Agenda Item: **V10-039 Riverside Drive (Public Right-of-Way in front of 6380, 6400, 6420, 6450 Riverside Drive)**, Primary Variance from Section 109-225.a 1 and 2 of the Stream Buffer Protection Ordinance to Allow Encroachments into the Seventy-five (75) Foot Buffer and Setback Requirements

Variance Petition No. V10-039

Riverside Drive Sidewalk Installation

**CITY OF SANDY SPRINGS
DEPARTMENT OF COMMUNITY DEVELOPMENT
VARIANCE ANALYSIS**

BUFFER ENCROACHMENT PLAN

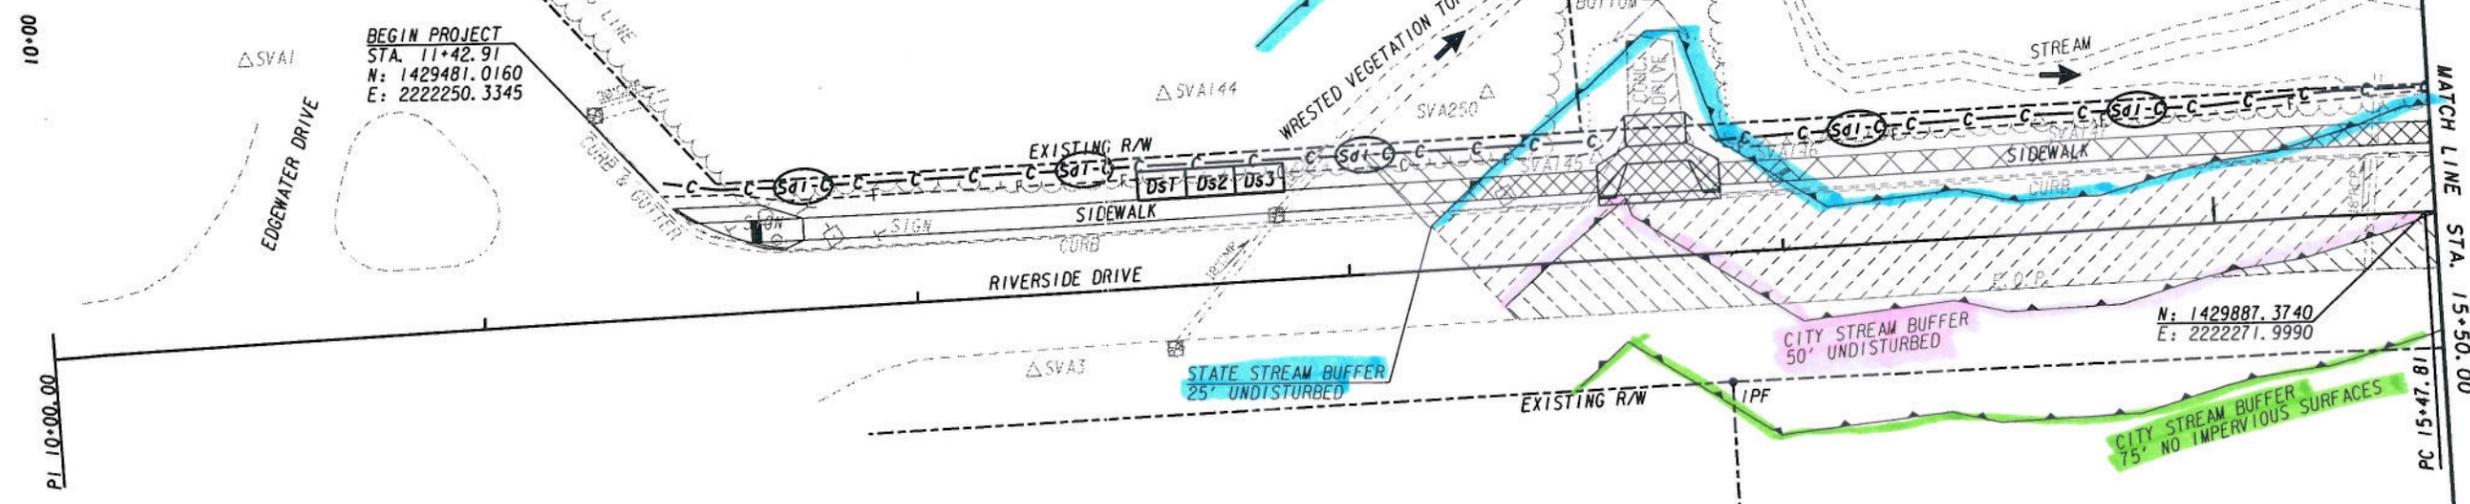
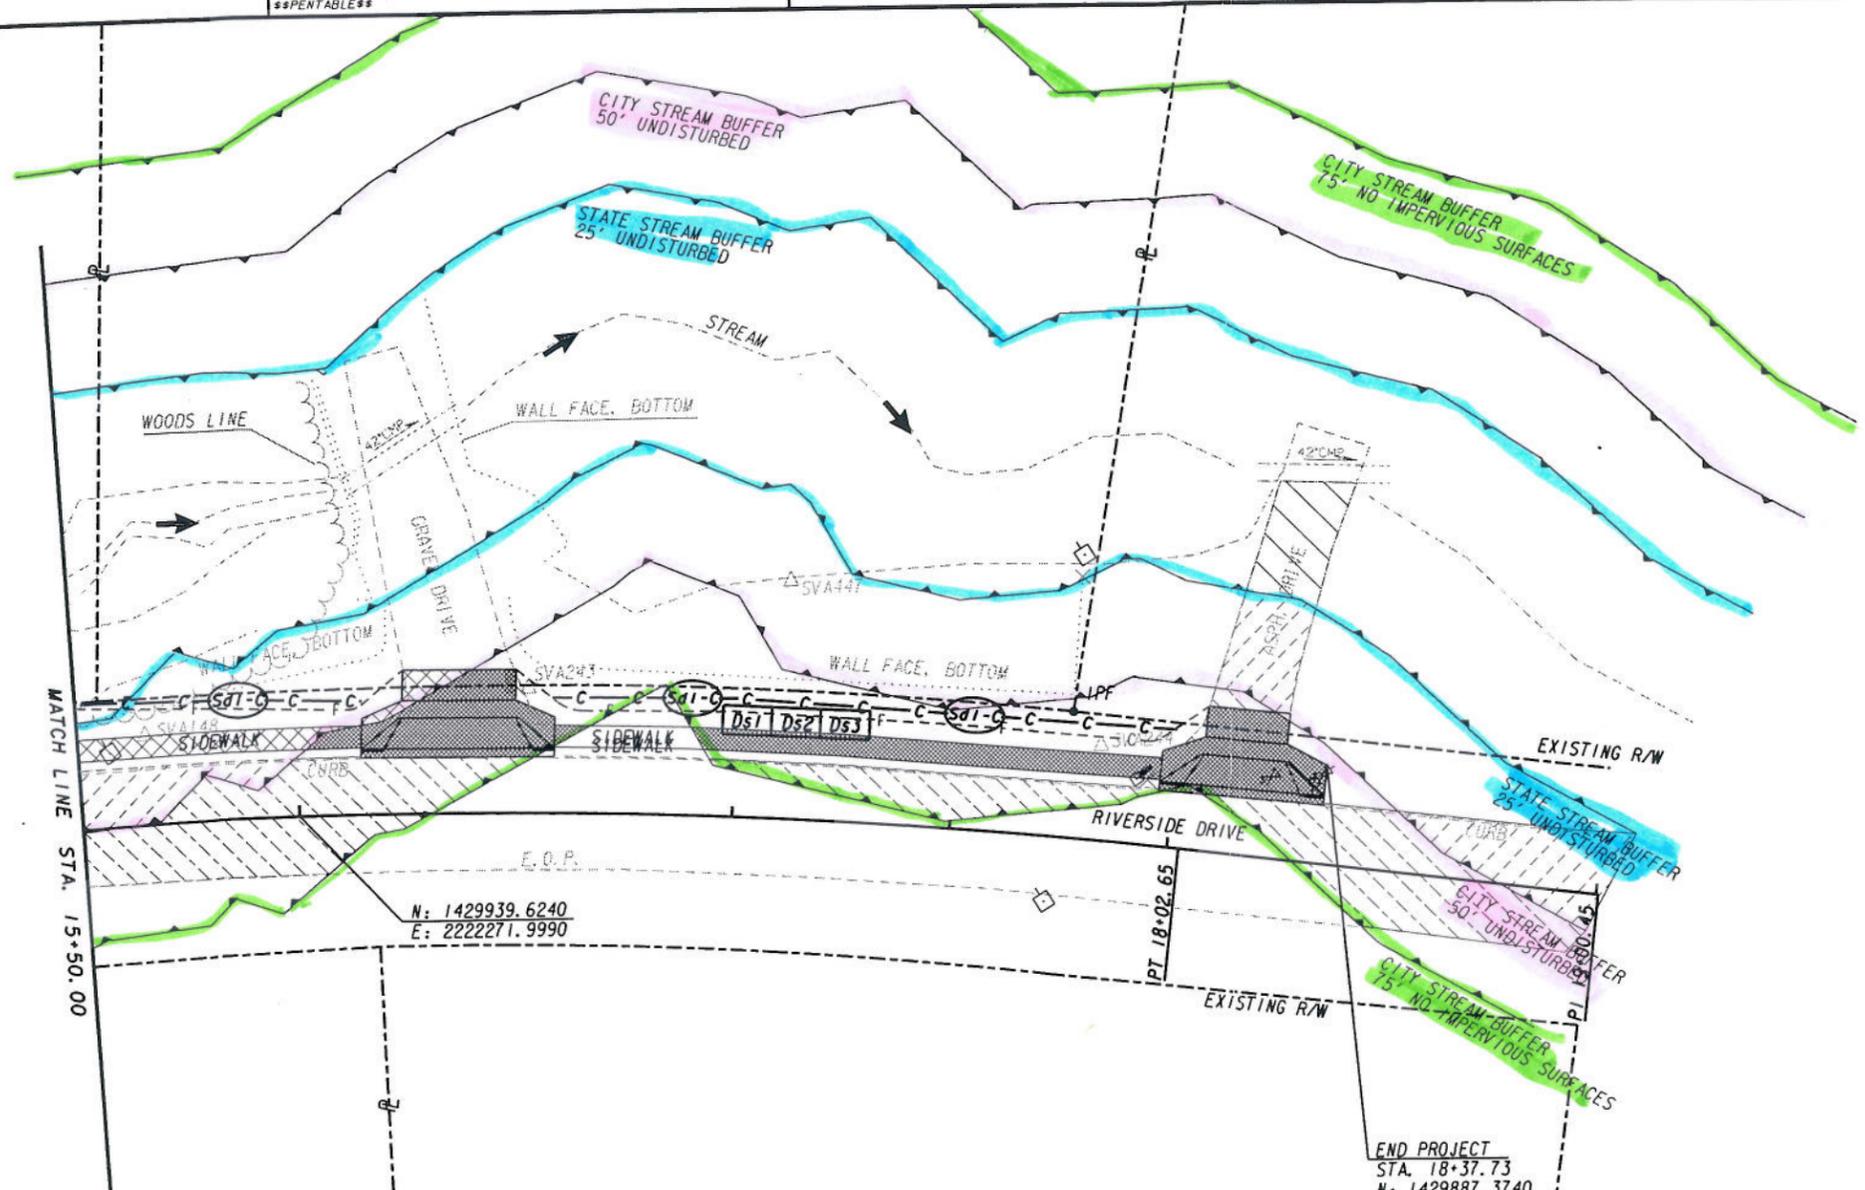
There is approximately two hundred eleven (211) foot section of the project that is impacts by the required twenty-five (25) state stream buffer. four hundred forty (440) foot portion of the project limits falls within in the stream buffer area as shown on the site plan provided by the Public Works Department (Exhibit 2).

The stream buffer covers approximately four hundred forty (440) portion of the T-6010 project as shown on the site plan provided by the Public Works Department (Exhibit 2).

The proposed sidewalk will encroach two hundred eleven (211) feet into the state stream buffer. The existing area of impervious surface in the 50 foot undisturbed natural buffer (twenty -five (25) foot City and twenty-five (25) foot State) is 8,132 square feet. The T-6010 project would add 1,860 square feet of impervious surface to this encroachment. Additionally, the project would add 1,815 square feet of impervious surface into the 25 foot impervious surface setback.

- 1) To the following stream buffer encroachments as shown on the site plan received by the Department of Community Development on October 26, 2010:

Buffer	Area of Encroachment (square feet)
25 foot state/city buffer	2,557
50 foot undisturbed natural buffer	16,477
25 foot impervious surface setback	15,282
TOTAL	17,064
